# Wisconsin Department of Transportation

**Proposal #10: 1228-09-73**  
**IH 43 North South Freeway**  
**Mitchell I/C to Marquette I/C**  
**IH 43**  
**Milwaukee County**

This is Addendum No. 02, which provides for the following:

**ADDENDUM NO. 02**

PROJECT NO: 1228-09-73	COUNTY: MILWAUKEE	CONSTRUCTION DETAIL	SHEET 17	E
FILE NAME: I:\PDS\CD\12280903\5SHEETS\PLAN\021001_CD.DWG	FLY BY: SPAETH, MICHELE L	PLOT NAME:	PLOT SCALE: 1 IN=100 FT	WISDOT/CADDS SHEET 42
LAYOUT NAME: 021002_04	PLT DATE: 2/1/2022 9:38 AM

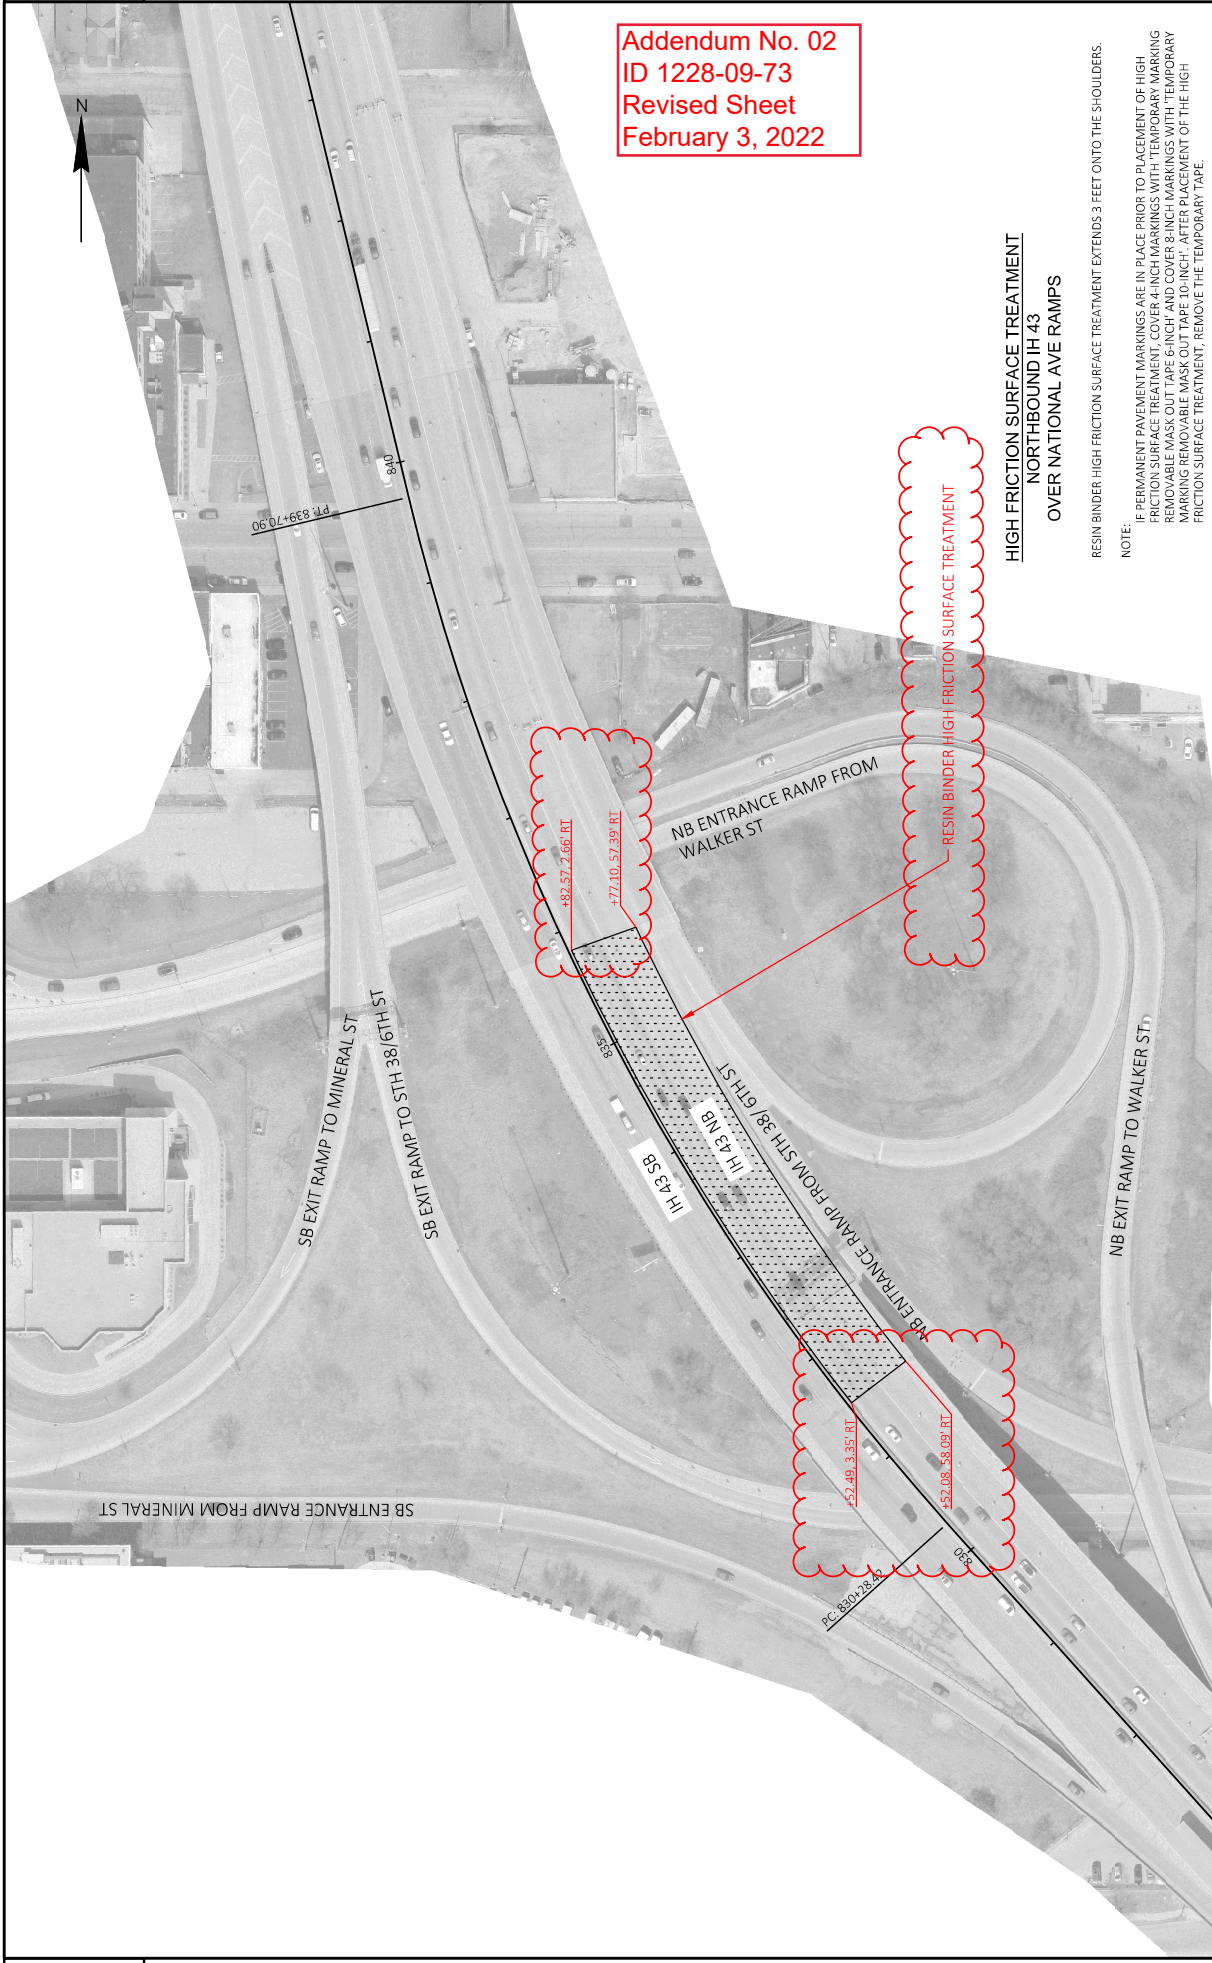
<b>Revised Plan Sheets</b>	
Plan Sheet	Plan Sheet Title (brief description of changes to sheet)
17	Construction Detail - Revised to clarify scope
18	Construction Detail - Revised to clarify scope
37	Construction Detail - Revised to clarify scope
38	Construction Detail - Revised to clarify scope
362	Miscellaneous Quantities - Revisions
374A	Miscellaneous Quantities – Additional bid items

Addendum No. 02  
ID 1228-09-73  
Revised Sheet  
February 3, 2022

HIGH FRICTION SURFACE TREATMENT  
SOUTHBOUND IH 43  
UNDER GREENFIELD AVE
